UNITED STATES PATENT AND TRADEMARK OFFICE

APPLICATION NO.	FILING DATE	FIRST NAMED INVENTOR	ATTORNEY DOCKET NO.	CONFIRMATION NO.
10/829,610	04/22/2004	Ian D. Parker	UC0306USNA	6868

Office Action Summary	Application No. 10/829,610	Applicant(s) PARKER, IAN D. 	
	Examiner Thinh T. Nguyen	Art Unit 2818

FIG. 5

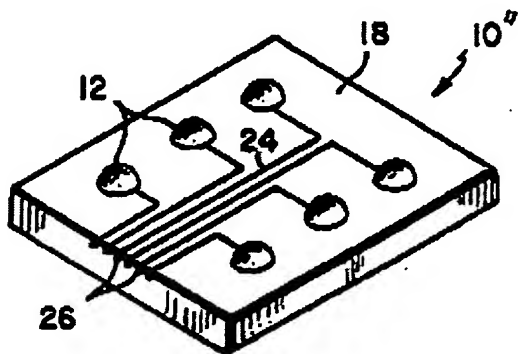
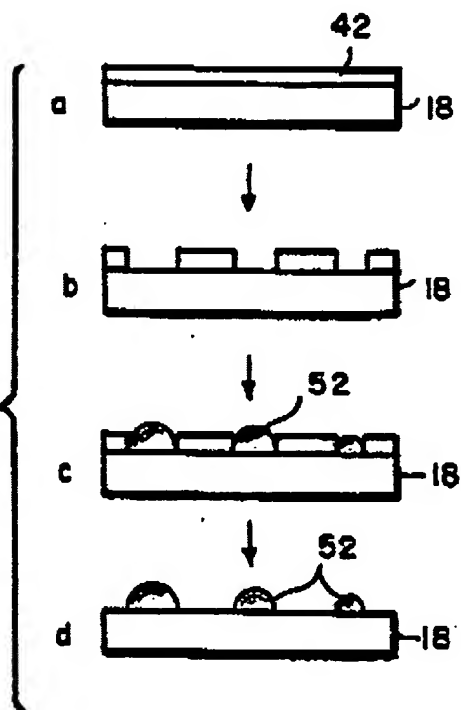
Rothschild (in the abstract, in fig 4, in fig 5, column 2 line 4-15) a device comprising: a substrate having a surface with a first portion and a second portion, without a well structure connected to or adjacent the first portion of the surface or the second portion of the surface, wherein the first portion of the surface has a first surface energy and the second portion of the surface has a second surface energy; and a liquid composition covering the first portion of the surface and contacting the second portion of the surface, wherein the liquid composition has a third surface energy that is higher than the first surface energy and lower than the second surface energy.

Moreover, even though Rothschild does not disclose that the liquid composition covering the first portion this limitation is either inherent from Rothschild disclosure since the Rothschild method and Applicant method is the same and therefore results in the same structure. That means

there are some partial covering of the first portion in the disclosure by Rothschild and effectively make it anticipates claim 11.

Noted that when a liquid composition is dropped over a substrate it will adhere primarily to the portion that has higher surface energy as disclosed by the Applicant in fig 9 and page 27 lines 1-5 of Applicant Specification in agreement with the disclosure by Rothschild on column 2 lines 15-16 of his disclosure.

Fig.7(a).
Self-alignment with large
wettability contrast

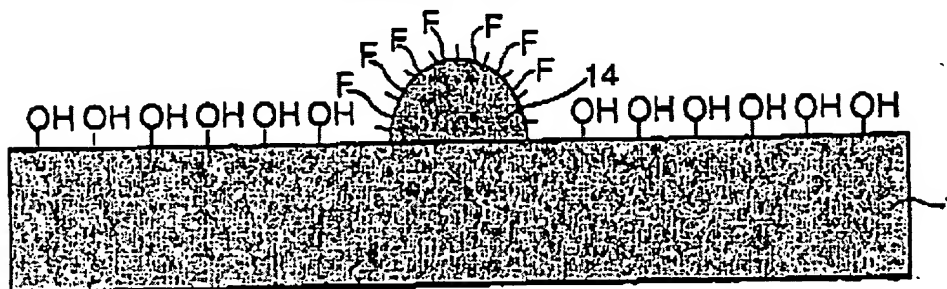
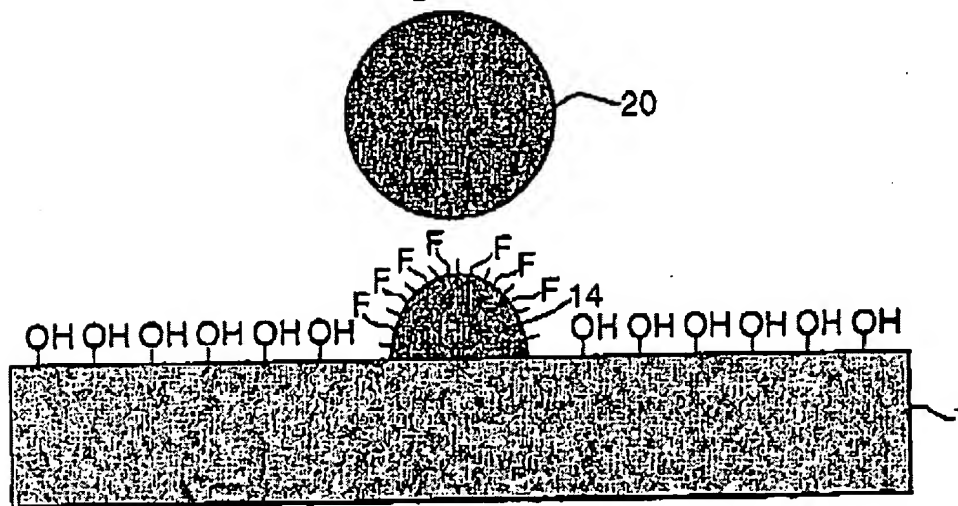
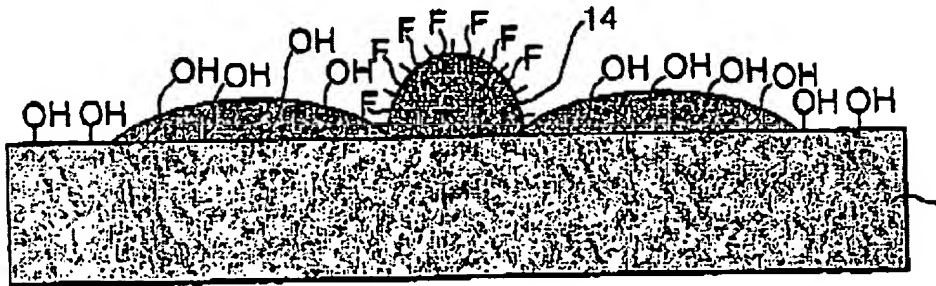
Takeo discloses (in fig 7(a), 7(b), 7(c)) the use of Fluorine surfactant.

The rationale why claim 15,16 is obvious over the Takeo 361 reference has been discussed in the rejection of claim 12.

Fig. 2

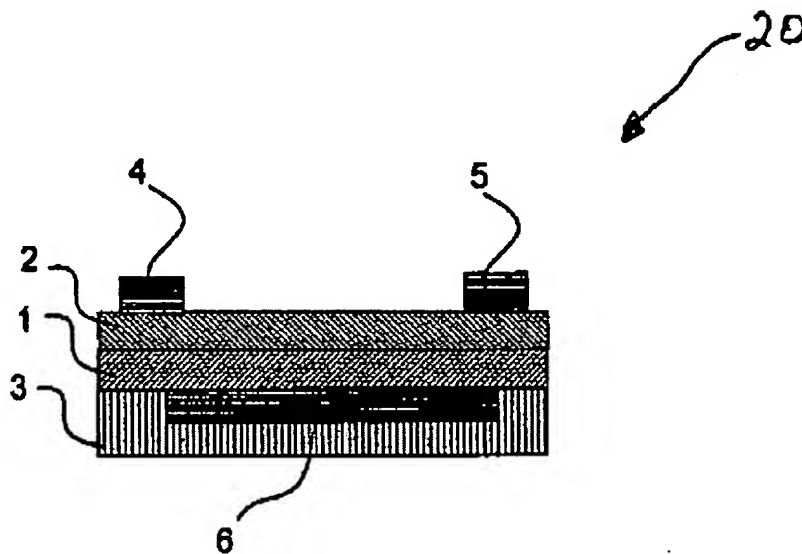
Mori (fig 2) disclose all the invention including a substrate with a portion that has electrode (fig 2 layer 6) and a portion with insulation layer (fig 2 layer 3).

Missing in the Mori disclosure is the specific formation of the organic electronics device using surface energy.

Takeo, however, in the abstract, discloses how to use the surface energy to pattern organic electronics device. It would have been obvious to one of ordinary skill in the art to combine the teachings by Ohtani with Takeo in order to come up with the invention of claim 13.
